[1] REDLINE REVISION 8/ /03

[2] REDLINE REVISION 10/ /03

MARYLAND DOT - STATE HIGHWAY ADMINISTRATION

MD 528 (COASTAL HIGHWAY) AND 65th ST.

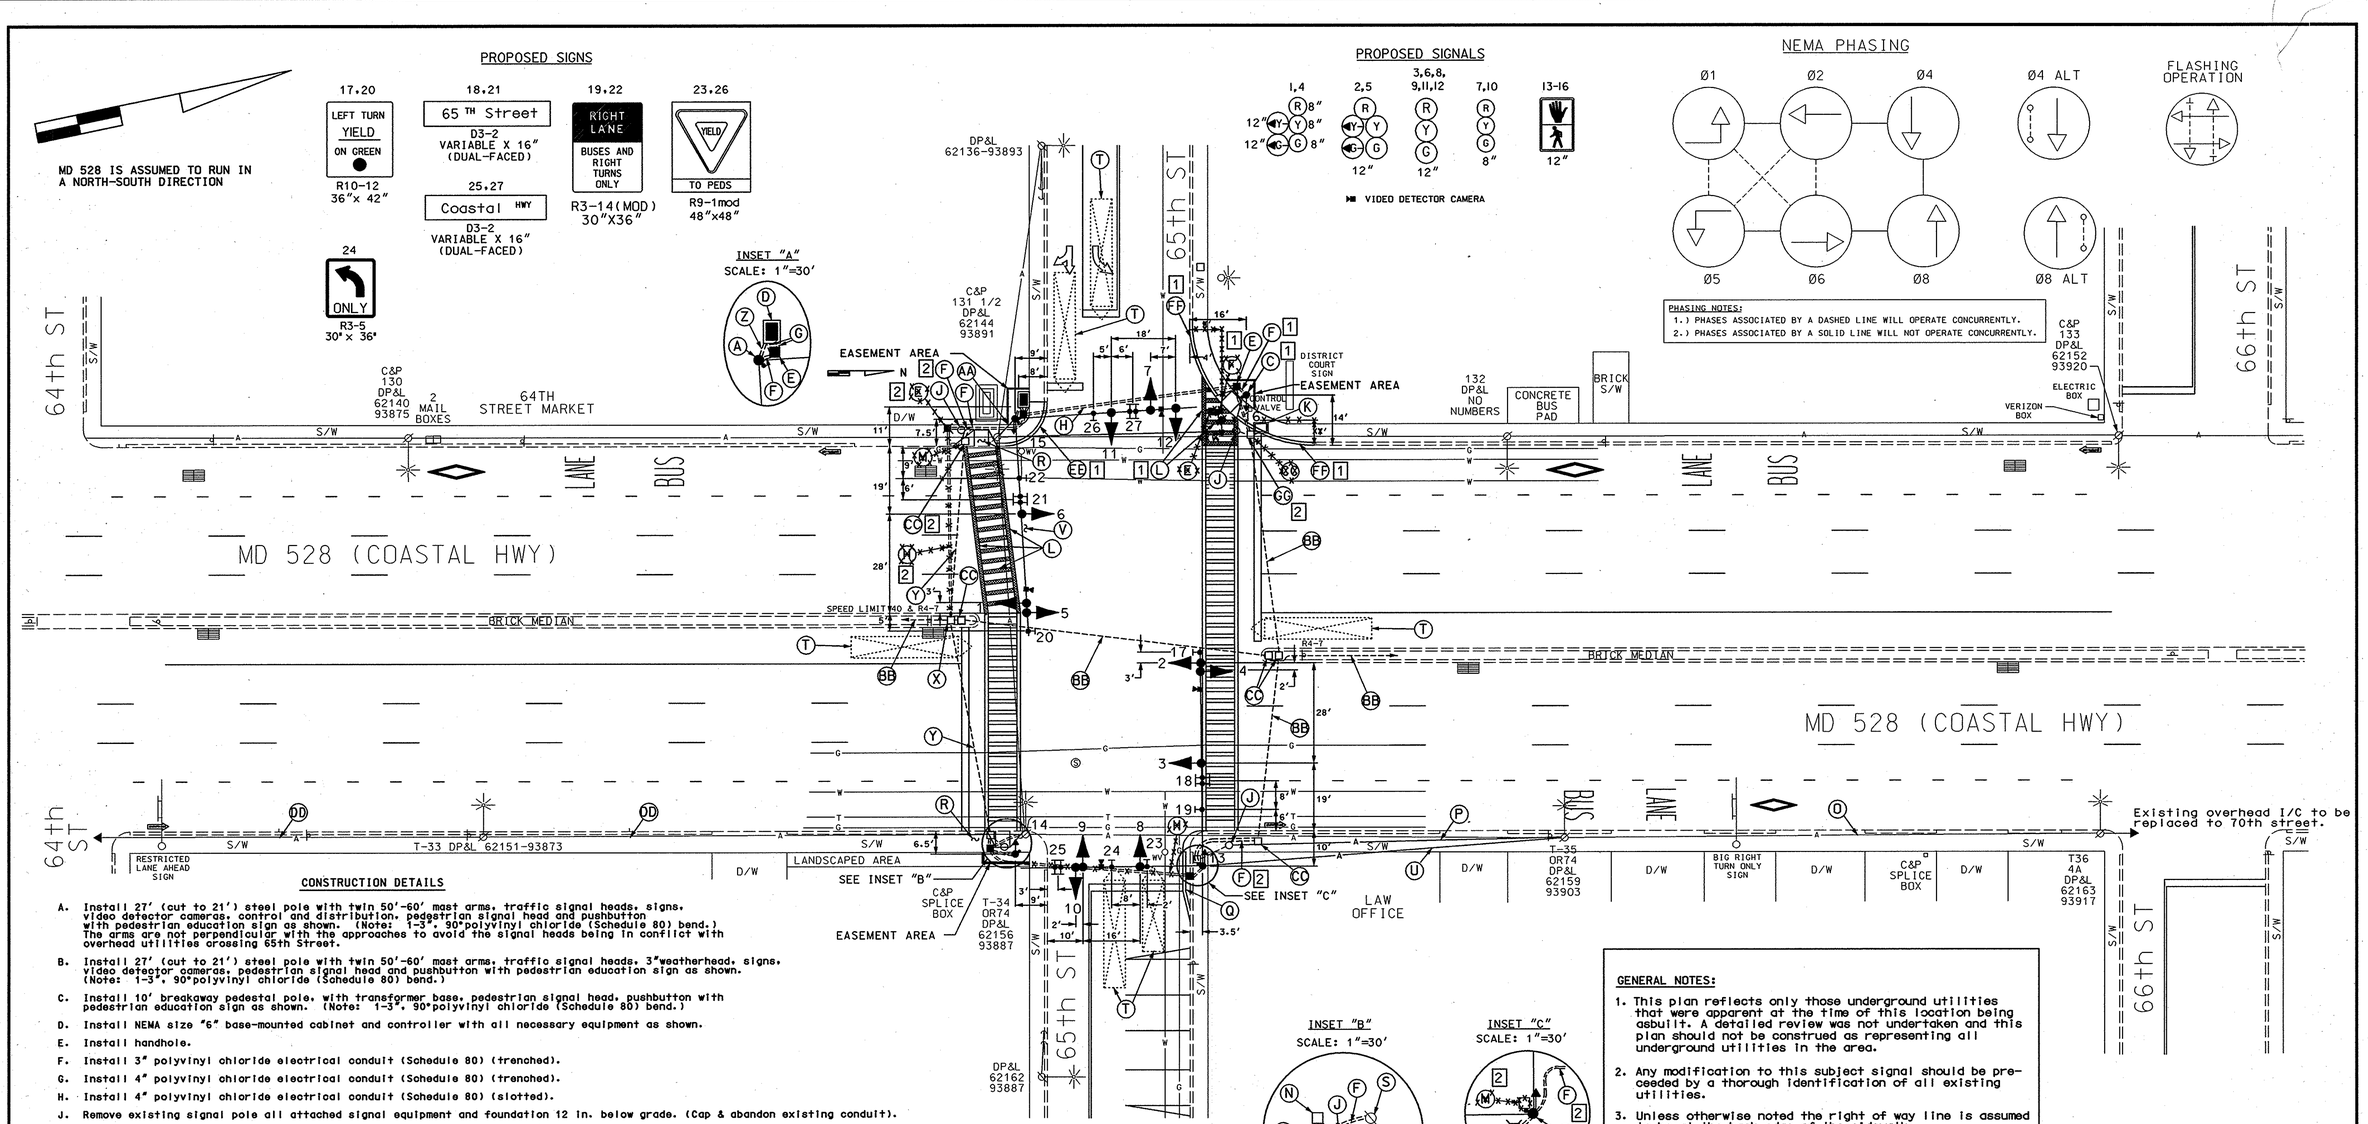
[2] S. Install 2"X" weatherhead and 2"X" PVC Schedule 80 riser onto existing utility pole. Attach elbow at pole base. Pullback existing overhead interconnect cable from controller to this utility pole and reroute thru proposed conduit into proposed controller.

[1] EE. Remove existing sidewalk and curb and gutter and install curb and gutter with a 12' radius as shown. Install new sidewalk.

[1] FF. Remove existing sidewalk and curb and gutter and install curb and gutter with a 35' radius. Install new sidewalk and handicapped ramp as shown.

[2] GG. Remove existing handhole and extend existing conduit from this handhole to proposed handhole as shown.
